Physics based justification on C_p value ratification

(A presentation in support of draft 1.4 comments #115, #116 and #117)

January 13, 2021

bois_3ck_adhoc_01_011321

Current topology for reference package (continued)

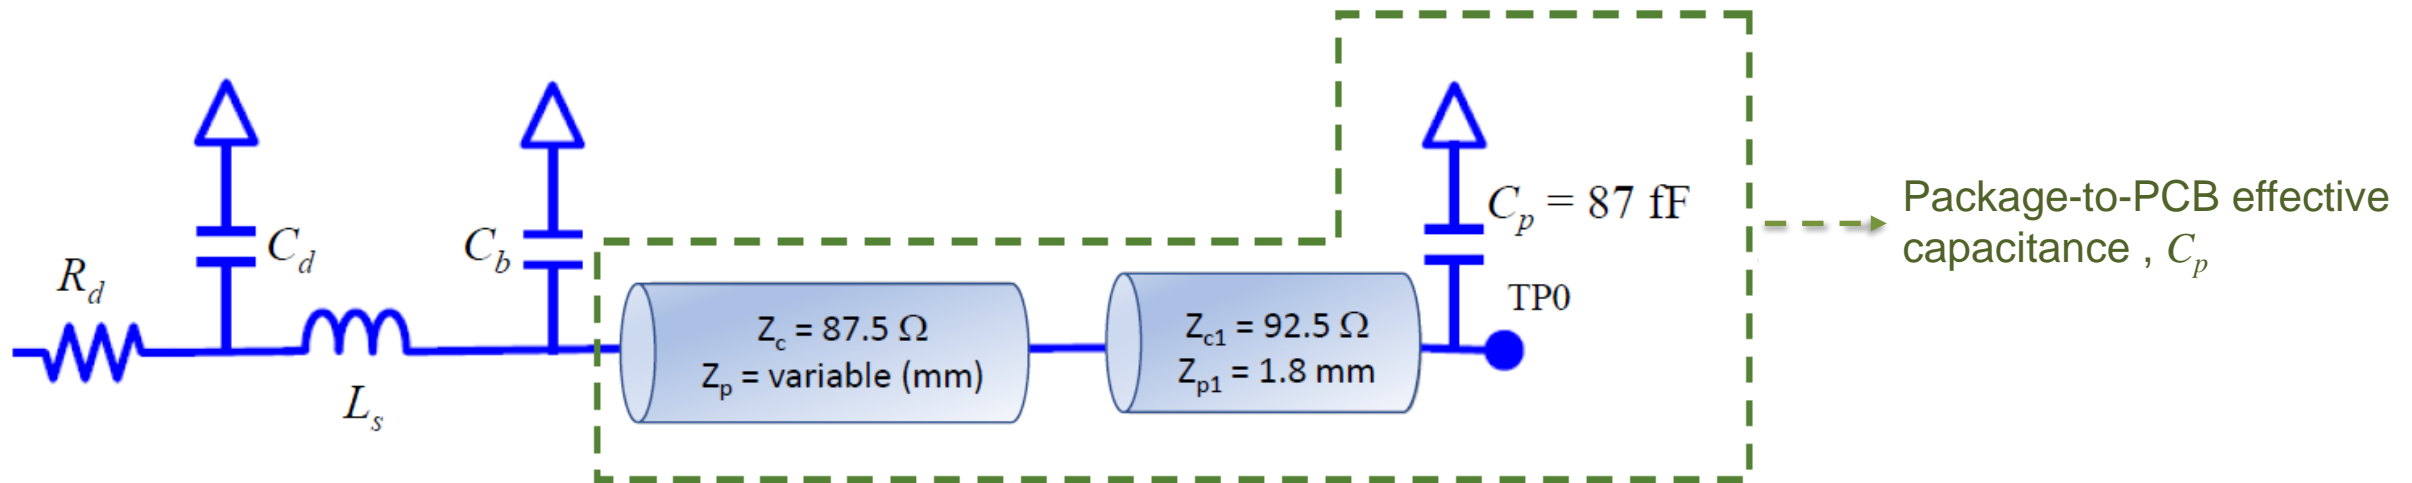
- The small effective transmission line section of the BGA is modeled using a shunt capacitor, C_p .
- Important note: modeling setup in 3D electromagnetic solvers will include a fraction of the PCB pad to BGA interface for port setup. Concatenated model overestimates the impact of the BGA region.

- As per comment for change request (#115, #116 and #117), C_p to be lowered to 60 fF.
- The proposed value translates to more accurate physical characteristic impedance of transmission line in the BGA field.
- The resulting impact of change: COM results for channel evaluation track more realistically physical implementation performance.
